REMARKS

Amendments to the Drawings:

The drawing sheets attached in connection with the above-identified application containing Figures 2-4 are being presented as a new formal drawing sheets to be substituted for the previously submitted drawing sheets. The drawing Figures 2-4 have been amended. Appended to this amendment is an annotated copy of the previous drawing sheet which has been marked to show changes presented in the replacement sheet of the drawing.

Fig. 2

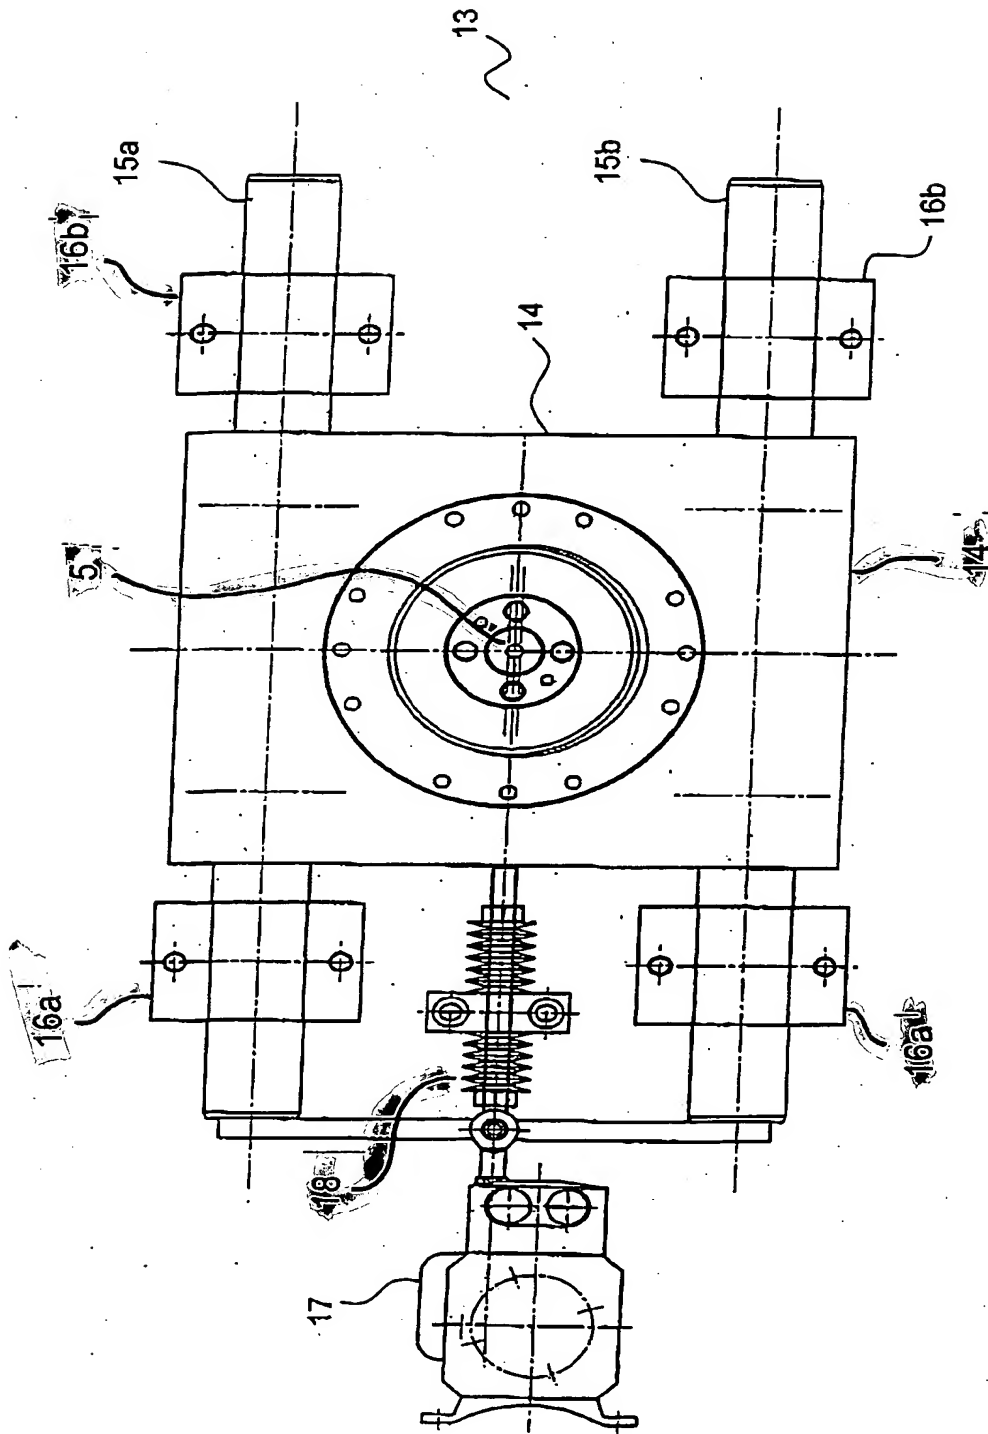
The drawings were objected to as failing to comply with 37 CFR 1.84(p)(4). Specifically, the Office Action states on page 2, "reference characters '7' and '14' have both been used to designate support." The specification and Fig. 2 have been amended to clarify that only reference numeral 14 refers to the support, thus overcoming this objection to the drawings.

The specific changes which have been made to Figure 2 are to change the reference numeral 7 to 14 for labeling the support. Figure 3 has been amended to include reference numerals 5, 14, 16a, 16b and 18 to label features mentioned in the specification. Figure 4 has been amended to extend the lead line from reference numeral 28 to the inner ring of bearing 24.

Fig. 3

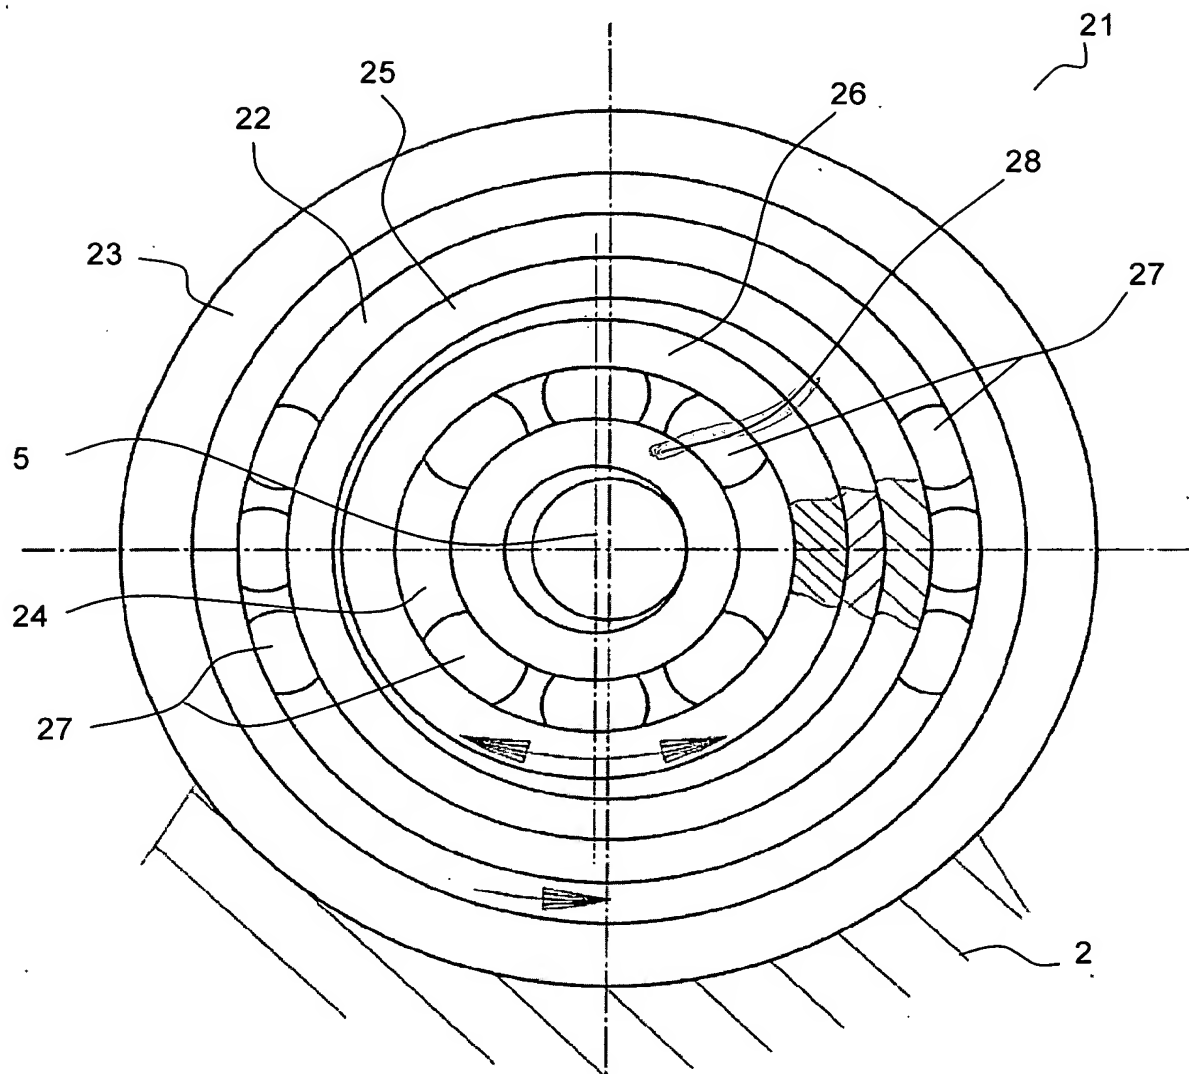
The drawings were also objected to for not labeling elements in Fig. 3, and in Fig. 4 because reference character 28 is not pointing to the inner ring of bearing 24. Fig. 3 has been amended to label elements not labeled, and Fig. 4 has been amended such that reference numeral 28 points to the inner ring of bearing 24, thus overcoming the objections to the drawings.
